PARK ADVISORY BOARD

Meeting Agenda

**Wednesday, August 12, 2026, at 1:30 p.m.
Fountain Creek Nature Center
320 Pepper Grass Lane
Fountain, CO 80817**

Agenda Item Title: Ben Lomand Mountain Village Preliminary Plan

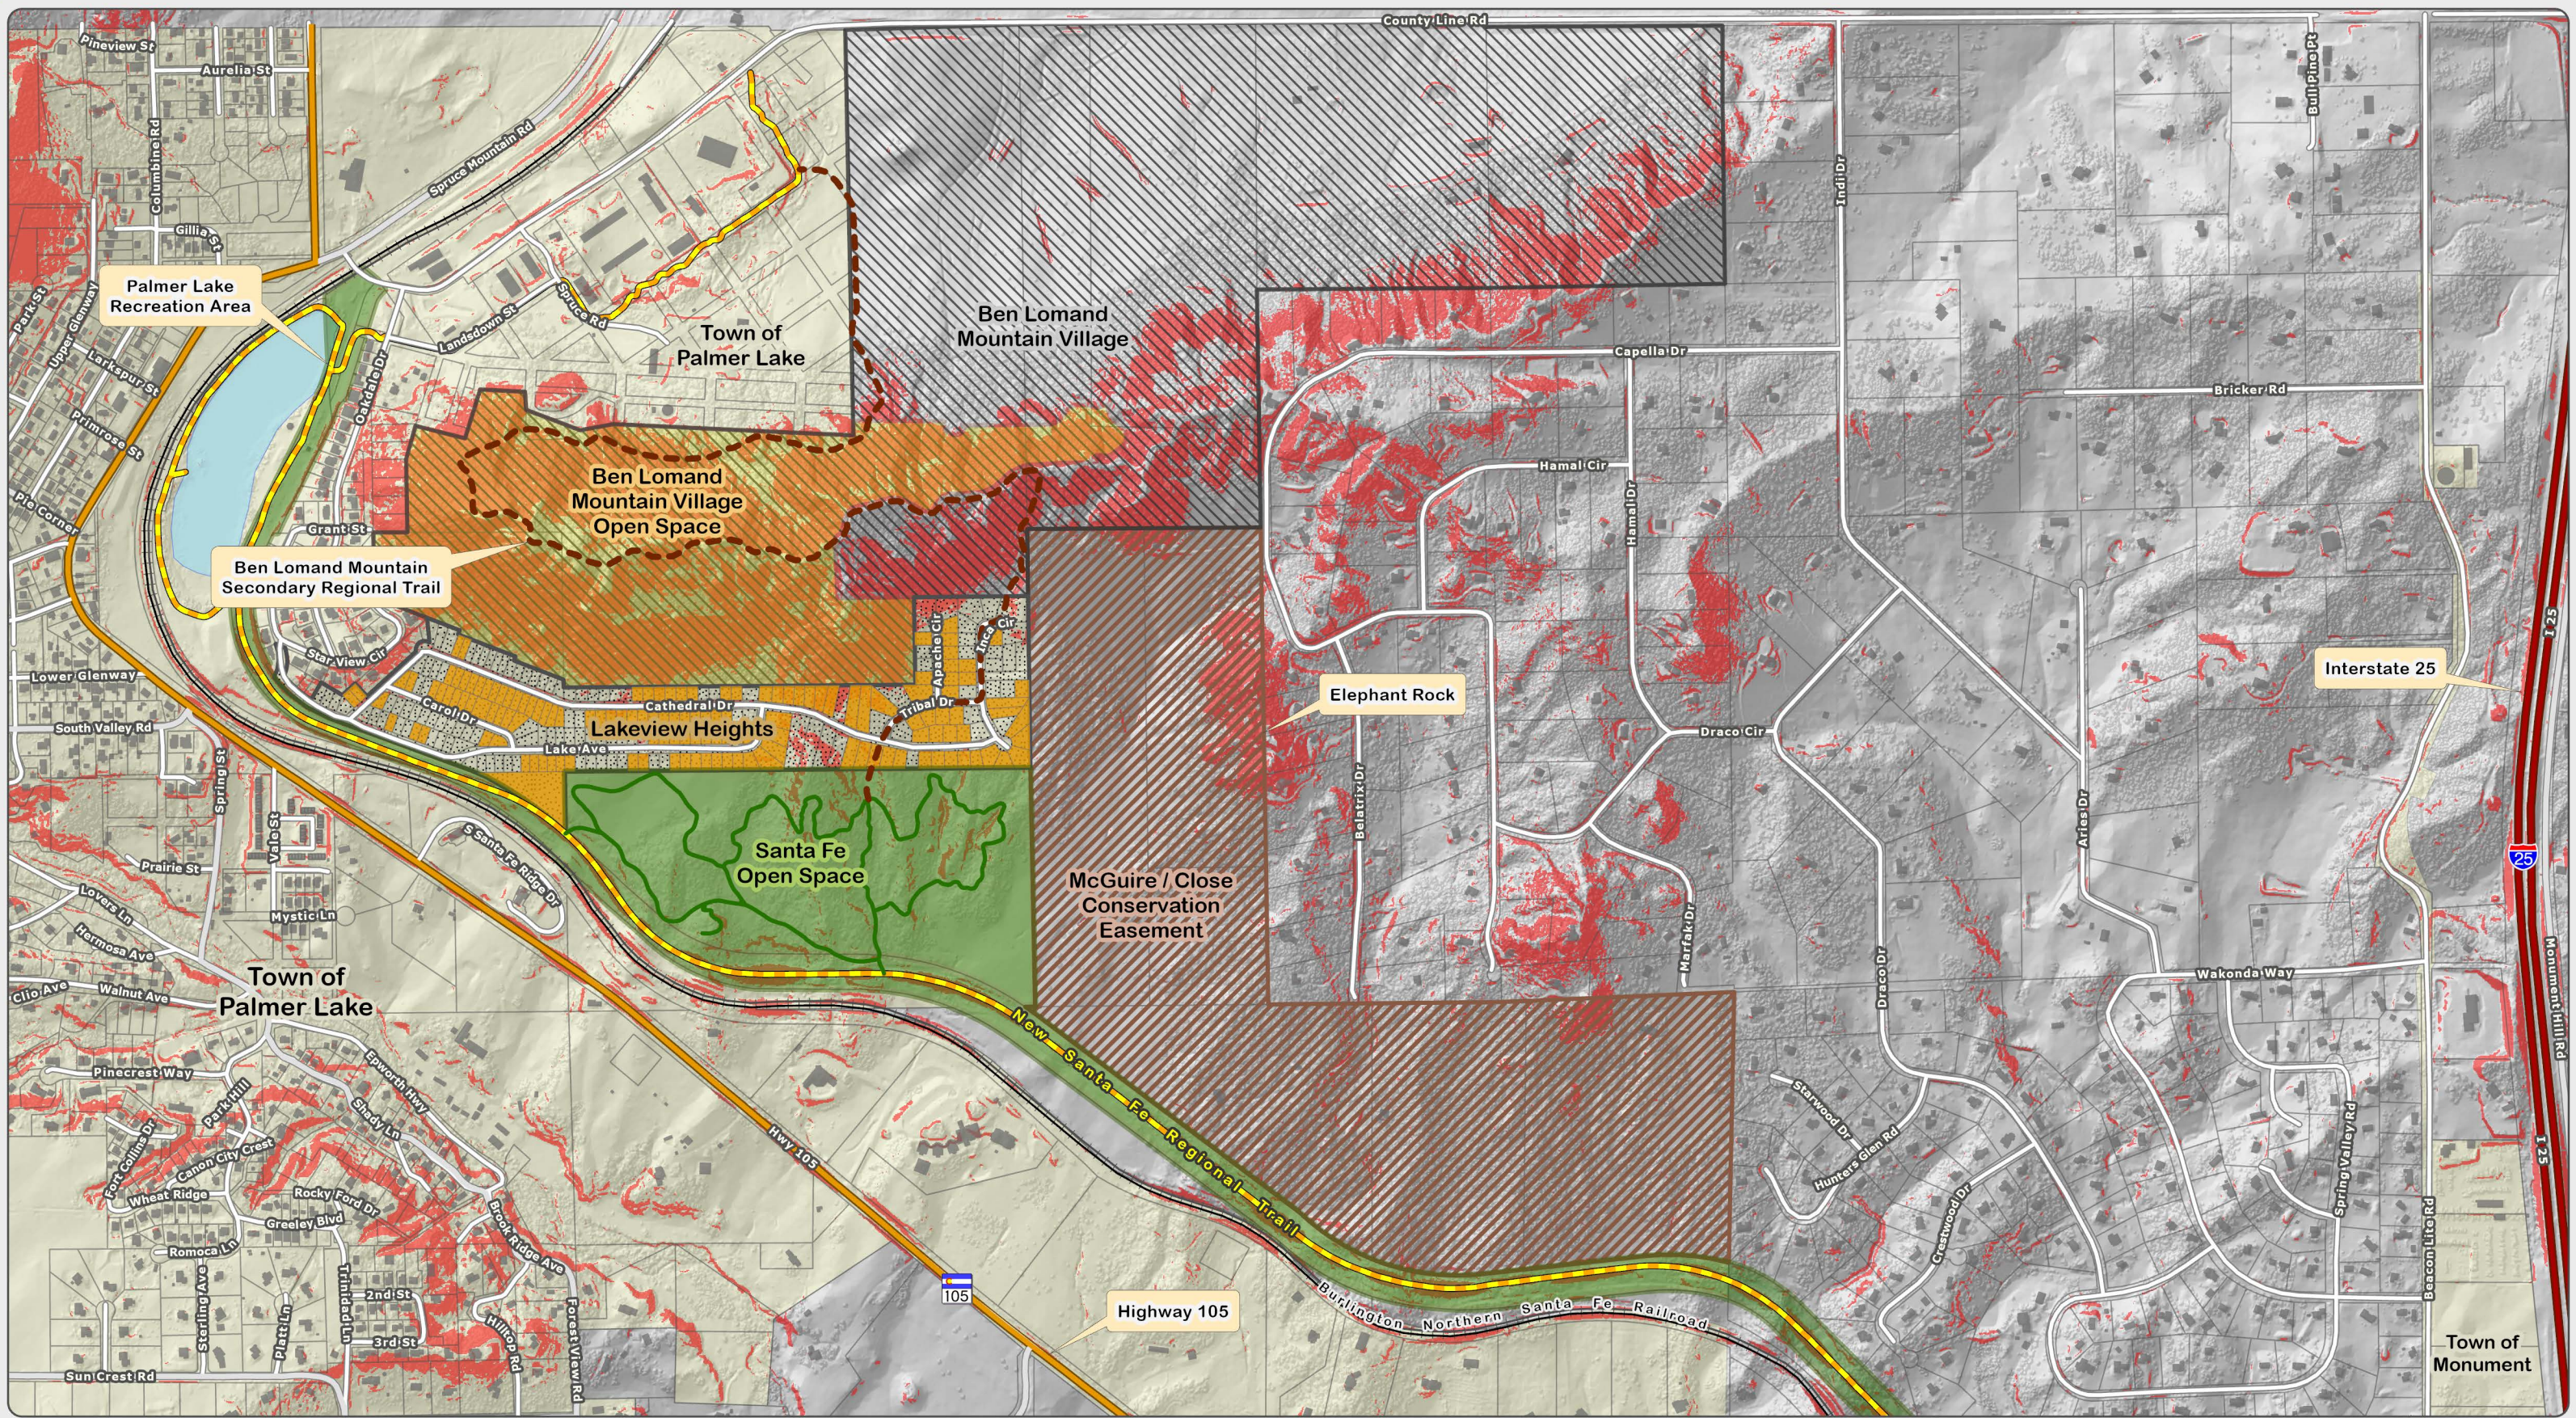
County Parks genuinely appreciates the applicant’s thorough attention to the conservation and preservation of Ben Lomand Mountain and its high open space values, through their proposed utilization of 100-acre Tract A as a wildlife sanctuary and open space amenity. Due to the proximity of the open space tract to Santa Fe Open Space, the New Santa Fe Regional Trail, and the Palmer Lake Recreation Area, as well as existing conservation easement properties to the south and southeast of Ben Lomand Mountain, El Paso County Parks has reached out to the applicant’s representative, Fairfield & Woods, to begin a conversation about the potential acquisition of the open space tract by the County, either through the land development process, conservation easement, outright purchase, or a combination of the three processes. At this time, Fairfield & Woods has not responded to EPC Park’s request for an introductory meeting.

The submitted Preliminary Plan shows Lots 1-7 located on the southern edge of Ben Lomand Mountain, situated above Santa Fe Open Space, Lakeview Heights, and privately-held conserved lands. Topographically speaking, these lots are generally steep in nature, with slopes measuring greater than 30 percent grade that offer few viable locations for the construction of residential units. Furthermore, these lots fall within the viewshed of Ben Lomand Mountain, and therefore, homes constructed here will be visible from points to the south. Although not a requirement of the endorsement of this Preliminary Plan by the El Paso County Park Advisory Board, El Paso County Parks suggests that the applicant reconsider the placement of these lots in the Preliminary Plan in order to preserve the high open space values – particularly viewshed and wildlife habitat – of the southern slopes of Ben Lomand Mountain.

Recommended Motion (Preliminary Plan):

The Park Advisory Board recommends that the Planning Commission and the Board of County Commissioners include the following conditions when considering and/or approving the Ben Lomand Mountain Village Preliminary Plan: (1) reconsider the placement of Lots 1-7 along the southern slopes of Ben Lomand Mountain; (2) recommend the applicant designate and provide to El Paso County 25-foot public trail easement through the subject property at a location to be determined by the applicant and El Paso County Parks that allows for public access, as well as construction and maintenance by El Paso County for the Ben Lomand Mountain Secondary Regional Trail, and the easements be shown, noted, and dedicated to the county via the forthcoming Final Plat(s). (3) fees in lieu of land dedication for regional park purposes in the amount of \$36,360 shall be due at time of the recording of the forthcoming Final Plat(s). A Regional Park Lands Agreement may be an acceptable alternative to Regional Park Fees, provided the Agreement is reviewed and approved by the El Paso County and executed by the El Paso County Board of County Commissioners prior to the recording of the Final Plat(s).
